Recall Bulletin

PRODUCT SAFETY RECALL

SUBJECT: Transmission Shift Cable Fracture

MODELS: 2004-2007 Chevrolet Malibu Maxx
2004-2008 Chevrolet Malibu
2005-2008 Pontiac G6
2007-2008 Saturn AURA
Equipped with 4-Speed Automatic Transmission (ME7/MN5)

4056223

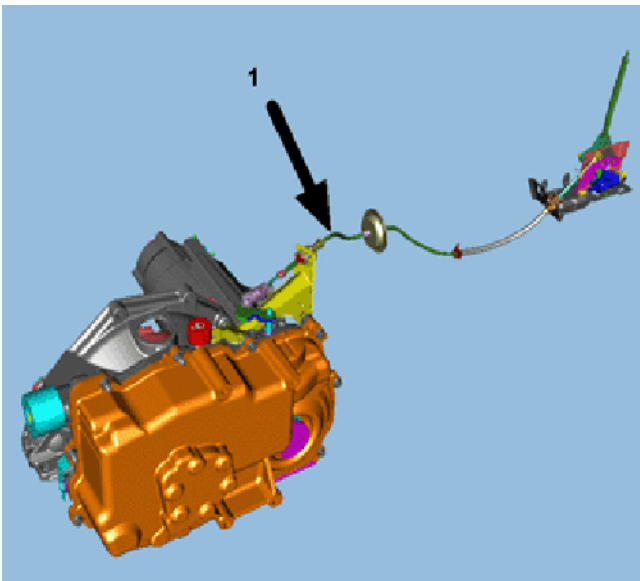
- If the shift cable makes a loop (1) before it attaches to the transmission shift lever, no further action is required.

4056216

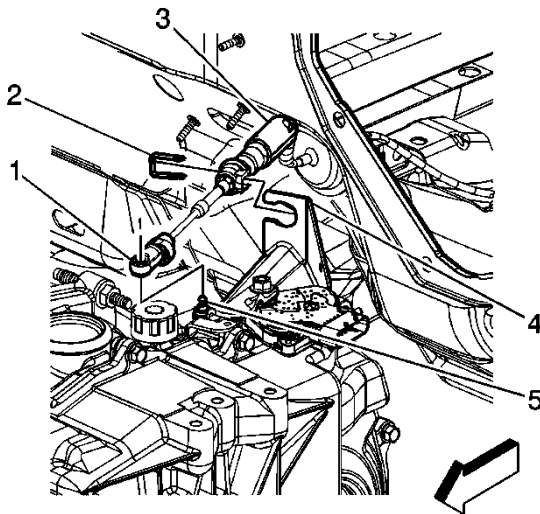
- If the shift cable routing is directly from the bulkhead to the transmission shift lever (1), proceed to the next step.
2. Remove and discard the floor shift control cable. Refer to *Floor Shift Control Cable Replacement* or *Range Selector Lever Cable Replacement* in SI.

2269484

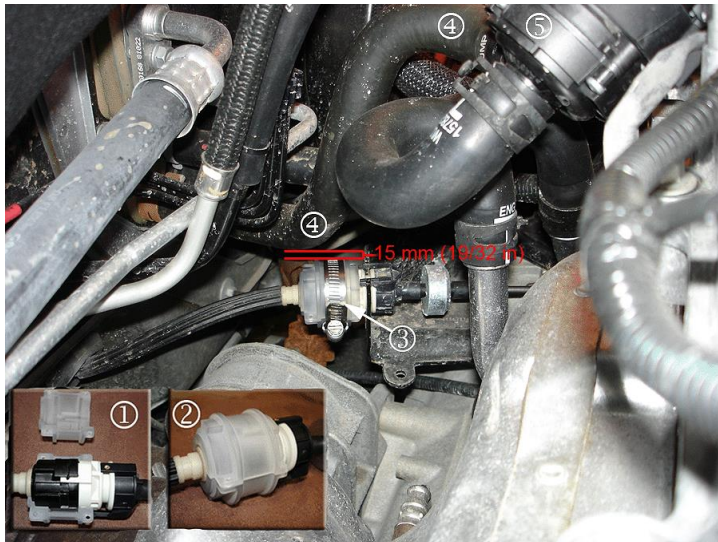
- (1) Clam Shell in Two Pieces
- (2) Clam Shell Around Shift Cable Locking Tabs
- (3) Clamp on Clam Shell
- (4) Inlet Coolant Hose and
- (5) Heater Cooler Pump.

5. Install the clam shell (1) (2) over the shifter cable locking tabs.
6. Install the service clamp over the clam shell (3). Position the clamp fastener head away from the inlet coolant hose (4). **Tighten the clamp to 4 N·m (35 lb-in).**
7. Ensure that there is 15 mm (19/32 in) of clearance between the inlet coolant hose (4) and the clam shell (3). On hybrid equipped vehicles, it may be necessary to reposition the inlet coolant hose (4) to achieve the required 15 mm (19/32 in) of clearance. **To reposition the inlet coolant hose (4) on hybrid equipped vehicles, locate the heater cooler pump (5) and perform Steps 7.1-7.5.**

Caution: Do not kink or damage the inlet coolant hose (4) when repositioning the hose to obtain the 15 mm (19/32 in) clearance. To avoid damaging the hose clamp, use J-38185 or equivalent hose clamp pliers to loosen the hose clamp.
